PHOENIX CONTACT Deutschland GmbH

Change of the solder pin guide of the PT 1.5 – SAA140690 product series Please forward this information to your electrotechnical departments!

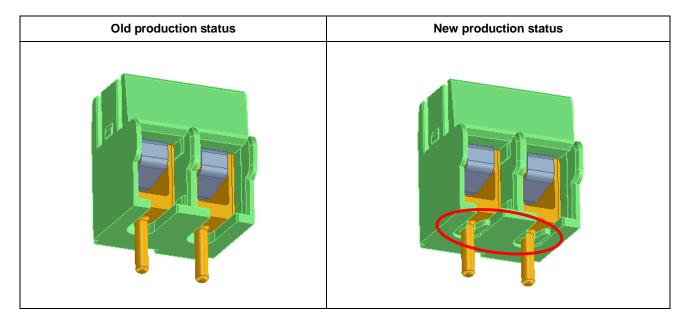
In the course of our continuous improvement process, the lower side of the housing is optimized in the area of the solder pins as part of a revision of a tool. As a result, the tight fit of the solder pins is improved.

The product series includes 2 and 3-pos. PCB terminal blocks. An increased number of positions results from the assembly of these components. The change only refers to the 2-pos. version. As regards combined terminal blocks, the differences cannot be seen from the front.

The technical features and the dimensions will not be affected by this change.

The existing stock can still be used. The new version will be delivered as of February 1, 2015.
